AUTOMATIC TRANSMISSION SERVICE GROUP

REVISED EDITION

Since the introduction of the THM 440-T4 Transaxle in April, 1984, there have been many major engineering design changes. These changes have affected nearly every part used in the THM 440-T4. This Update Handbook will explain each change, the parts affected by the change, and any parts interchangeability problems created by the change.

Figure 21

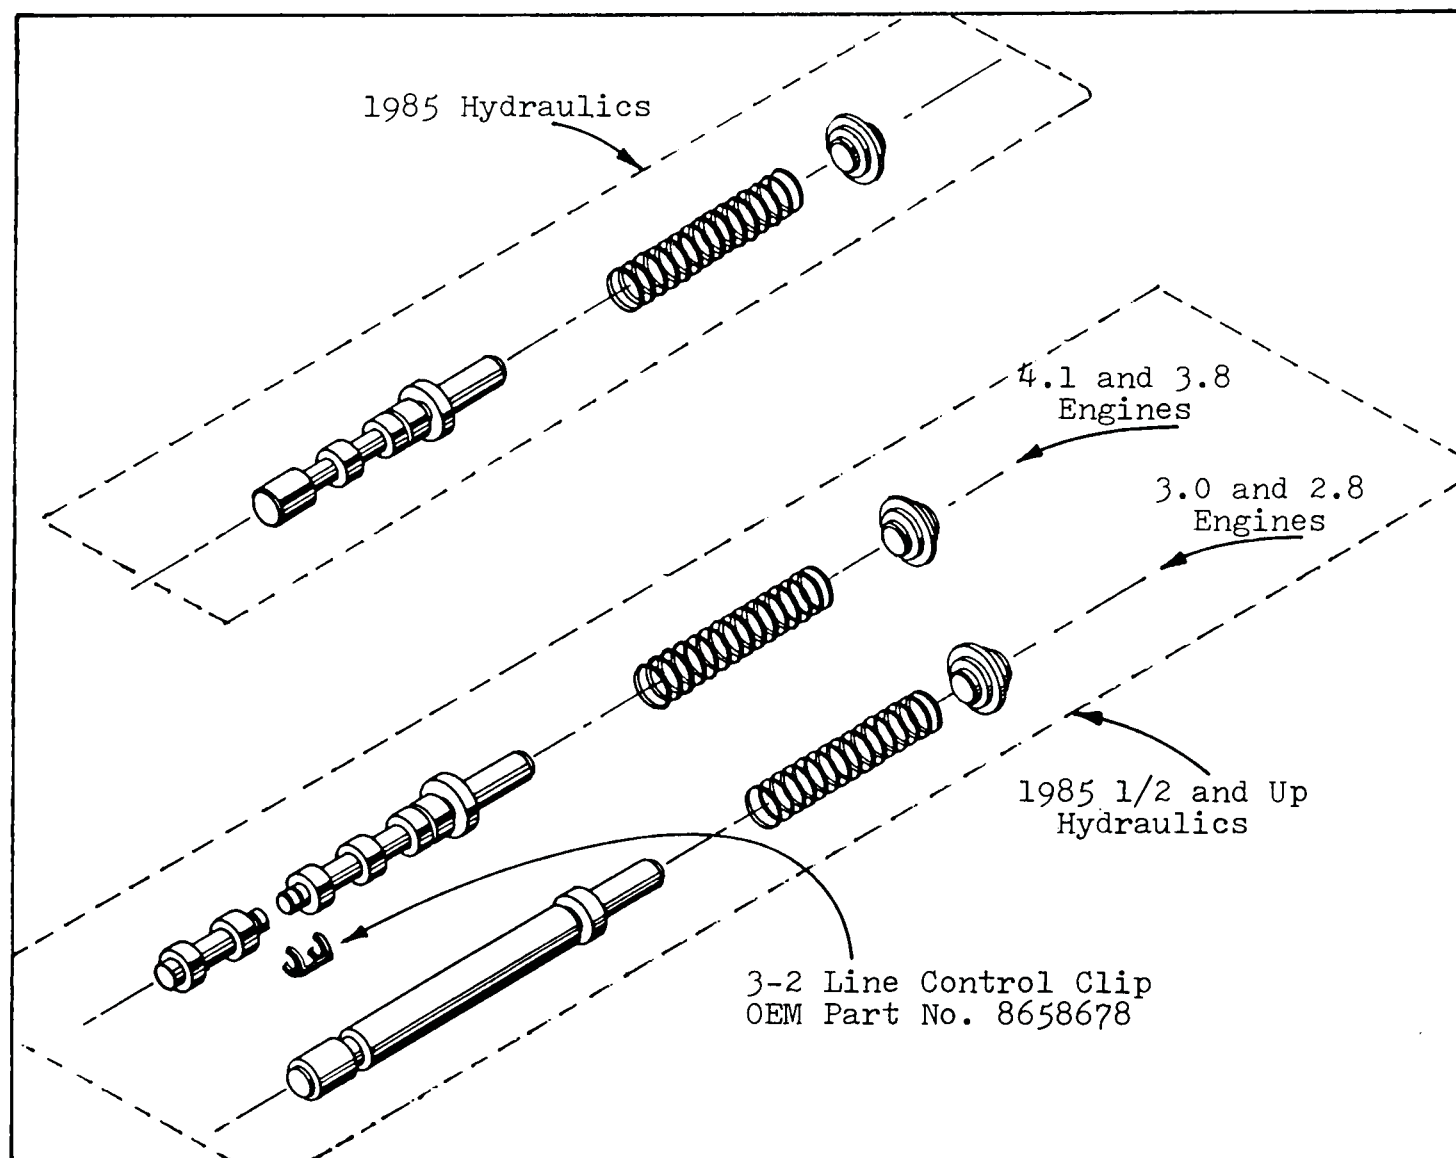
- 2) The 3-2 line control valve located in the channel plate (See Figure 20 For Location), was changed from a single valve, to a two piece valve (See Figure 21). The 2 piece is connected together with a small clip that has a bad habit of breaking, and will create no 3-2 downshift.

Also notice (See Figure 21) that there are 2 line ups for the 85 1/2 and up models. The 2 piece 3-2 line control valve is used on 4.1 Cadillac, and 3.8 Buick engines. The "Plug" that is also shown (Figure 21), is used on 3.0 Buick, and 2.8 Chevrolet engines.

This makes the channel plates non-interchangeable on these models. This also affects the valve body spacer plate, and makes the spacer plate non-interchangeable on these models.

Figure 22

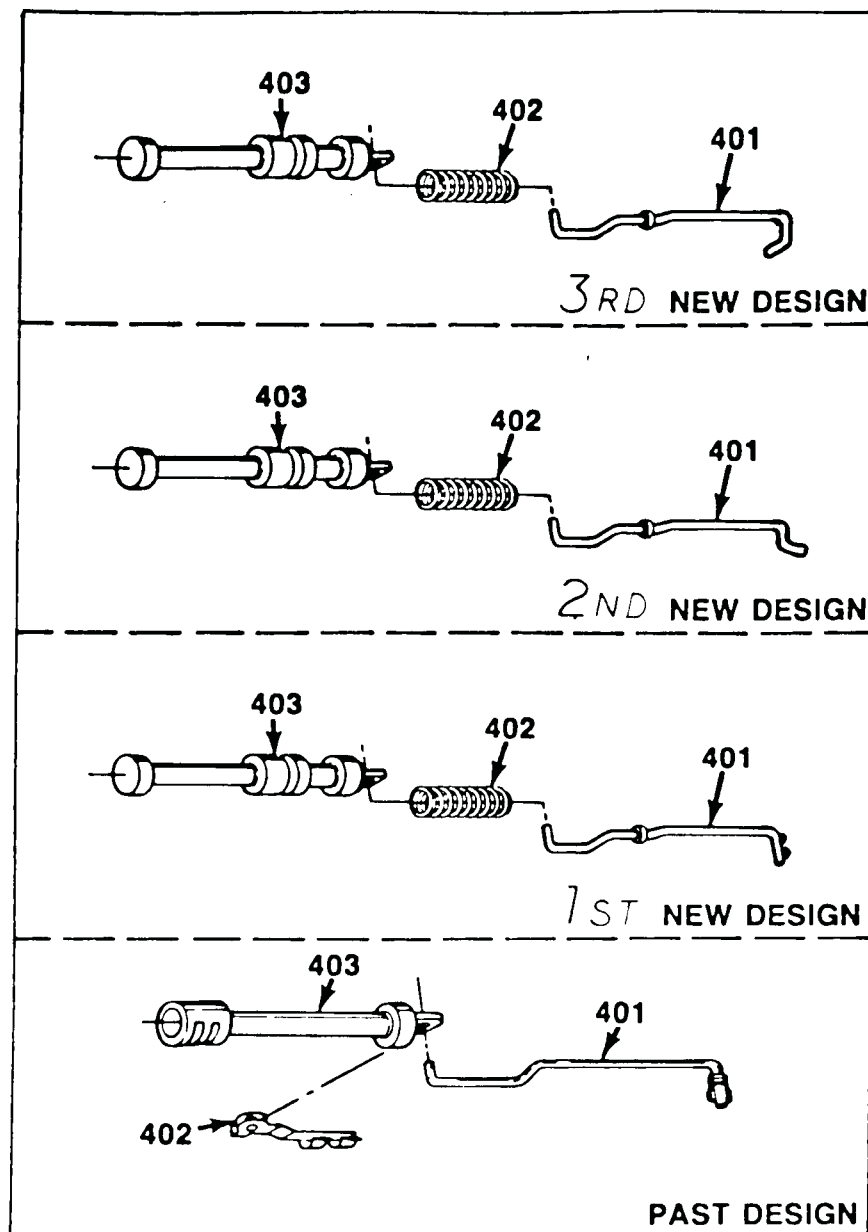
- 3) There has also been some re-design of the manual valve, retainer clip, and manual link to assist in the assembly process (See Figure 22).

Figure 23

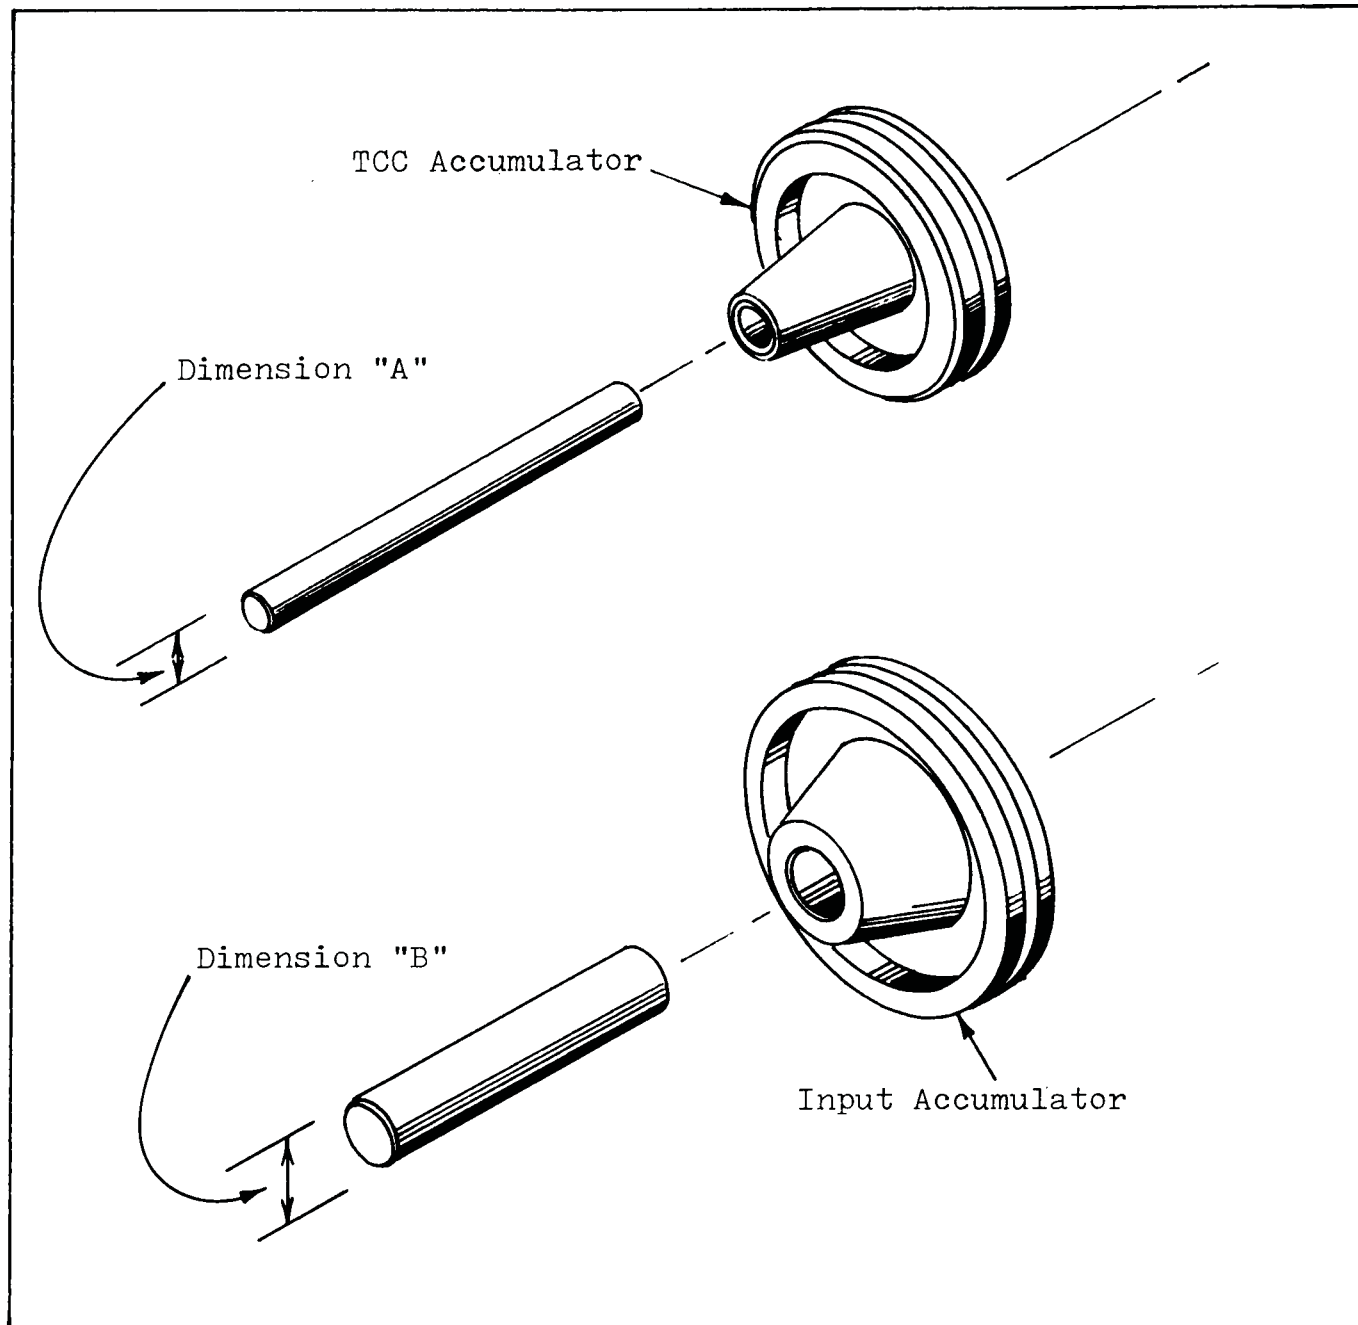
In mid 1985 the dimensions of both the TCC accumulator pin and piston, and the input accumulator pin and piston changed. We have included the dimensions of both early and late for identification purposes. (See Figure 23).

EARLY .309 Inches
LATE .314 Inches

Obviously you would not be able to install the late pin into the early piston, but you could go the other way very easily. Make sure you measure these pins and "Always" up-date to the larger 2nd design.

Figure 24

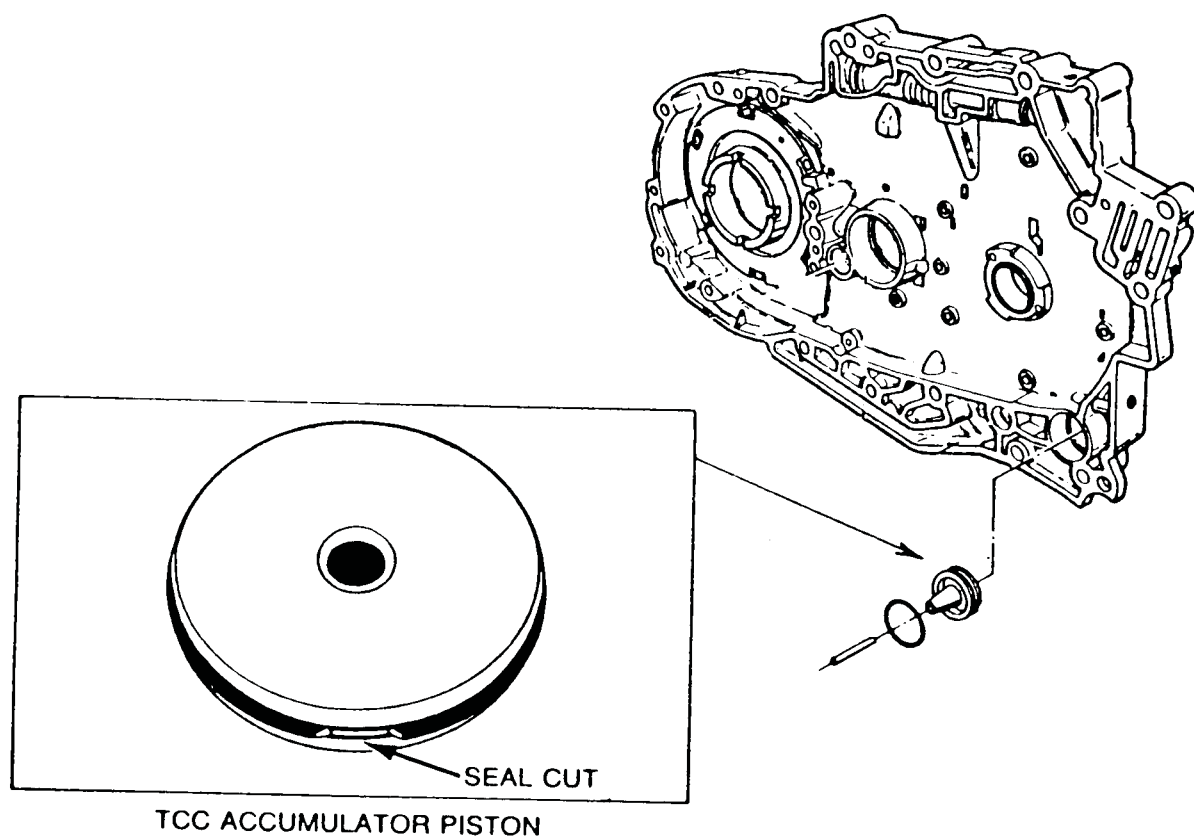
CAUSE: Some 1984 and some early 1985 THM 440-T4 transaxles may experience a no Torque Converter Clutch (TCC) apply or TCC shudder condition, which may be due to a cut or rolled TCC accumulator piston seal (See Figure 24).

CORRECTION: Install updated service package 8646926.
Updated service package 8646926 contains the following:

Figure 26

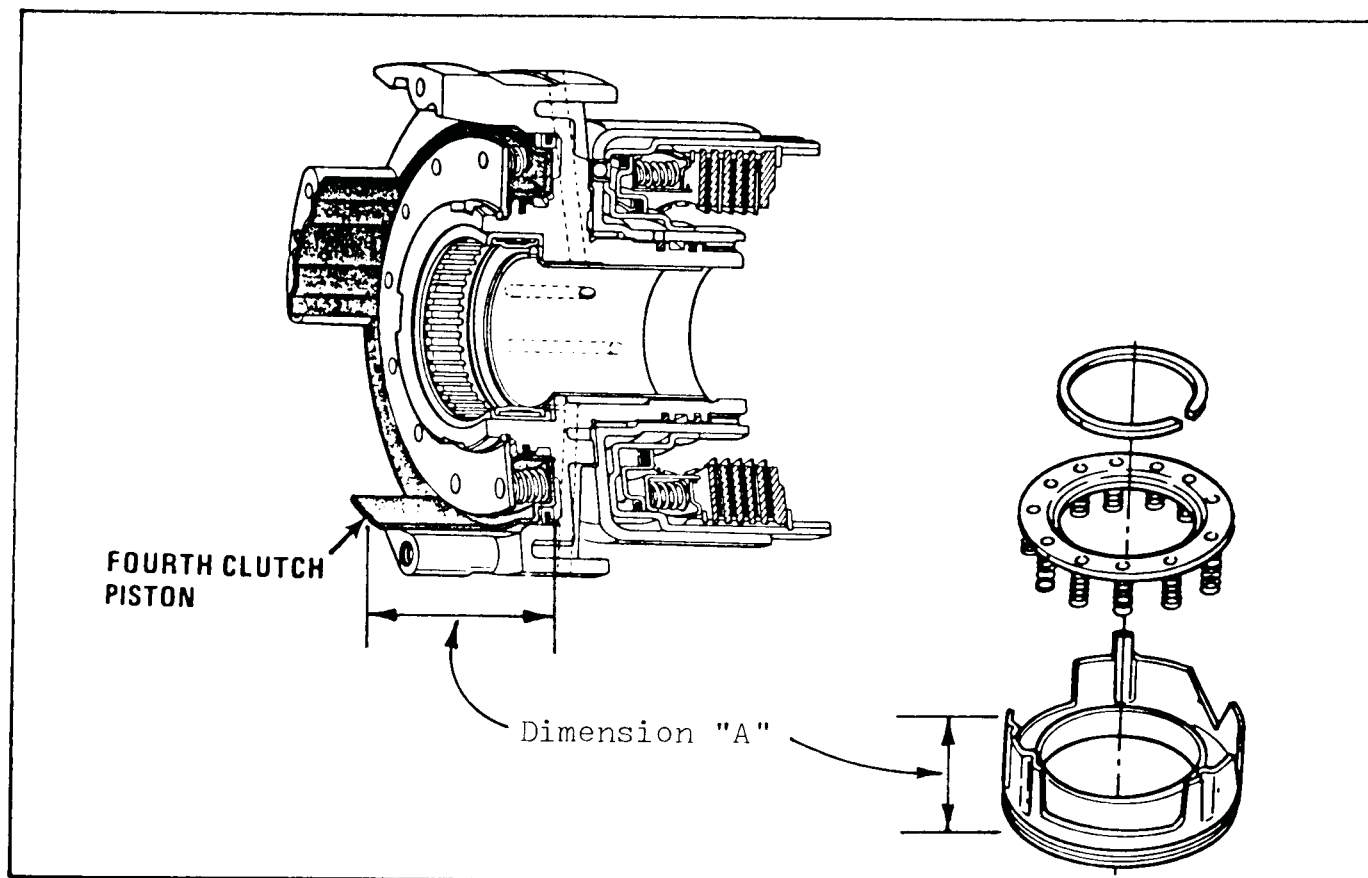
To identify, use a dial caliper set, and locked, at 1.930" and check as shown at dimension "A" in Figure 26. If dial caliper will go over the top of the piston, you have the late style piston.

If the dial caliper will not go over the top of the piston, the 4th clutch piston will have to be replaced with OEM part No. 8658388.

Figure 34

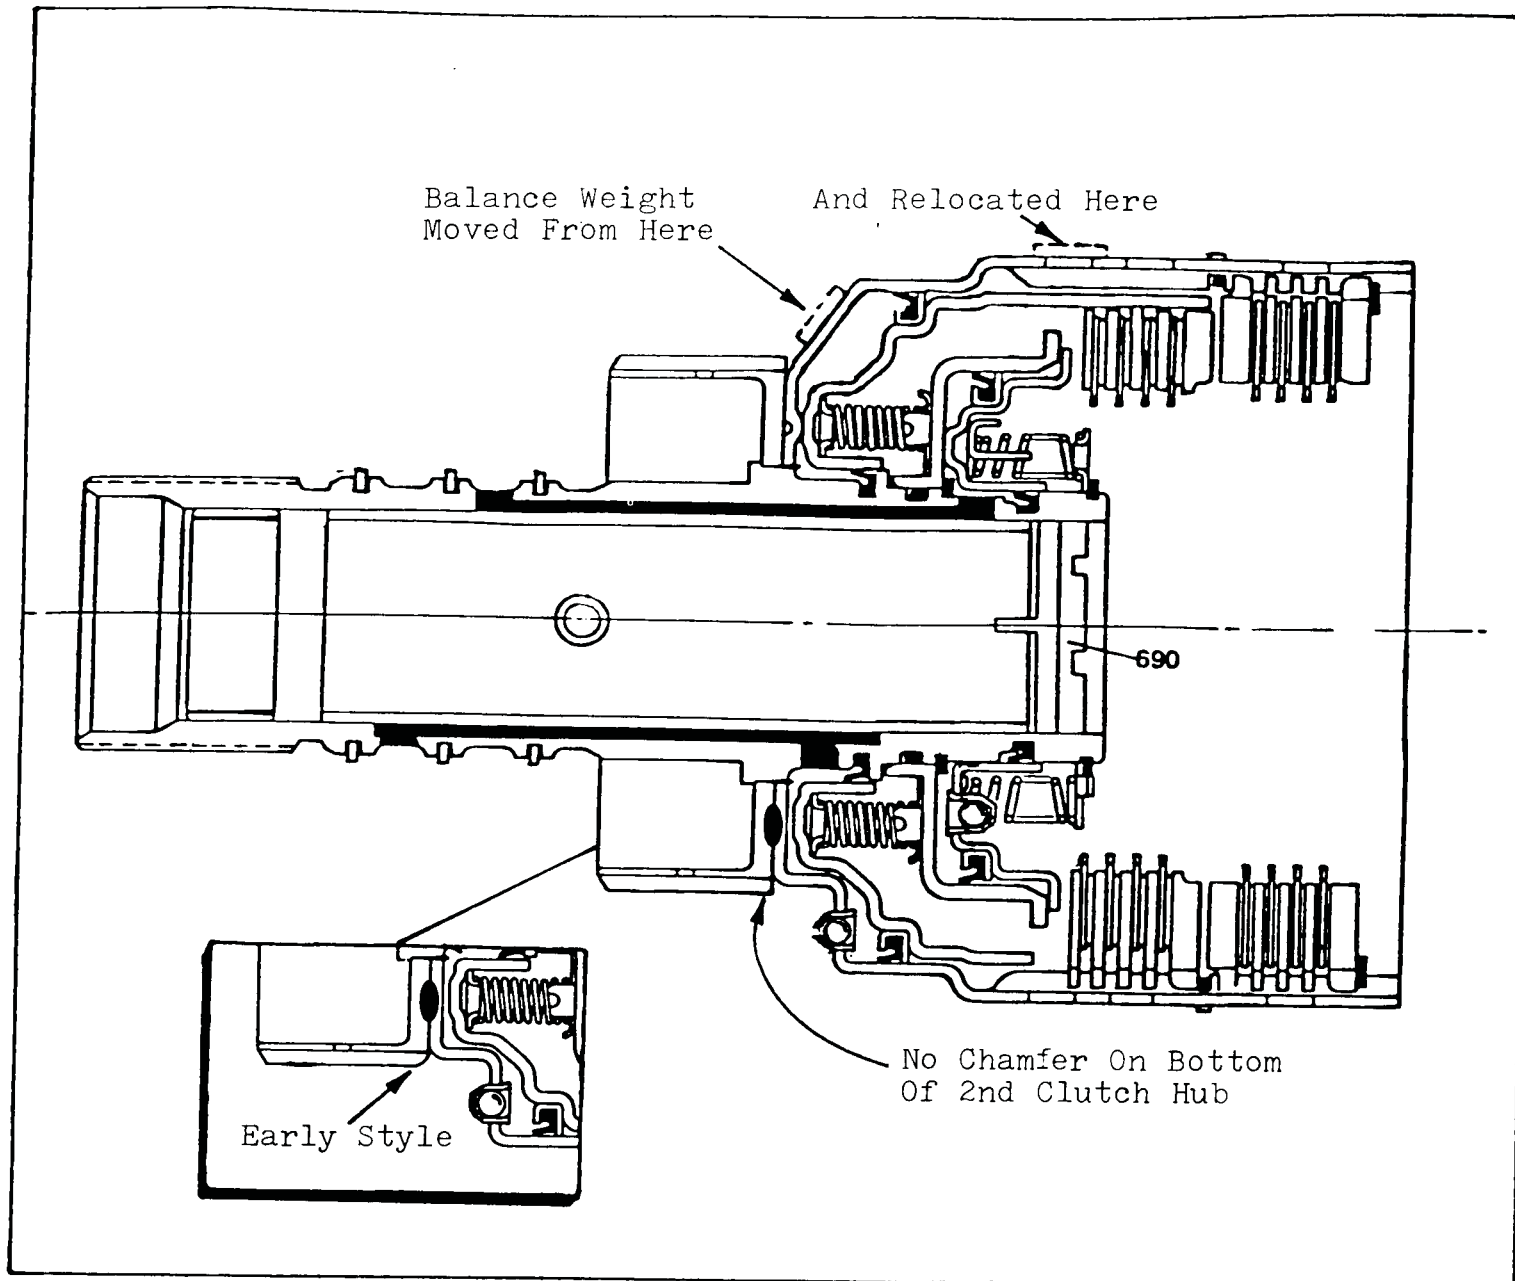
- 6) Input Housing - Revised balance weight location so as to eliminate interference with revised backing plate assembly (See Figure 34). Also no chamfer on bottom of 2nd clutch hub (See Figure 34).

The 6 plate 2nd clutch will retro all the way back as long as you have an input housing with no balance weight, or an input housing with the balance weight down on the side (See Figure 34).

Figure 35

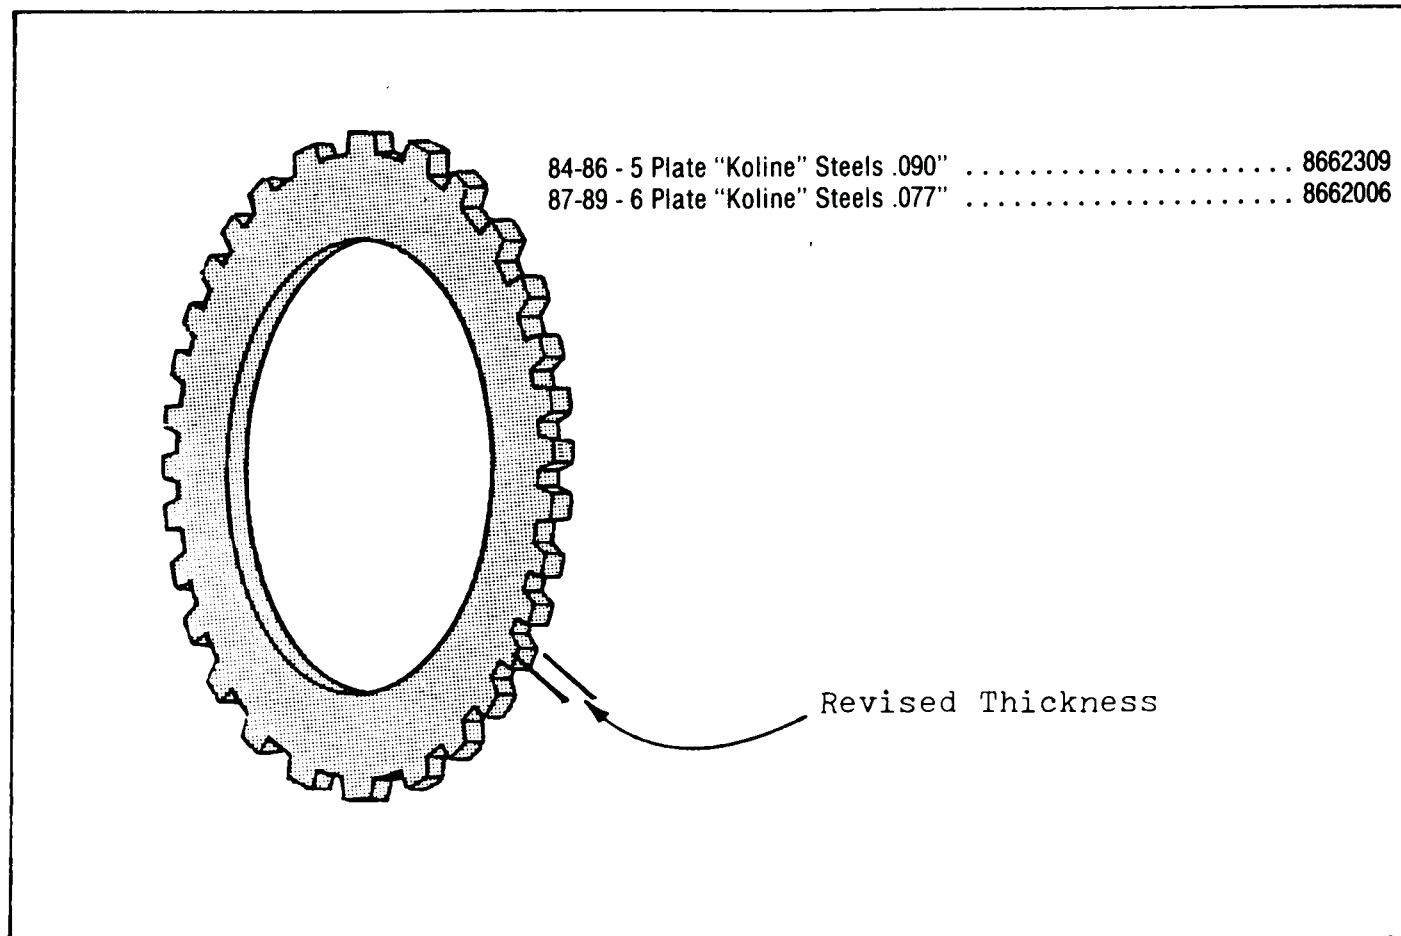
The steel plates in the 440-T4 2nd clutch are unique, in that they are black in color. They have a black coating on them called "Koline" plating, for shift pleasability (See Figure 35).

The thickness of the "Koline" plates were revised for 1987, with the addition of the 6 plate 2nd clutch pack (See Figure 35).

The 2nd clutch steel plates CANNOT be tumbled as it will remove the "Koline" plating. If the "Koline" plating is worn from the steel plates, they will have to be replaced.
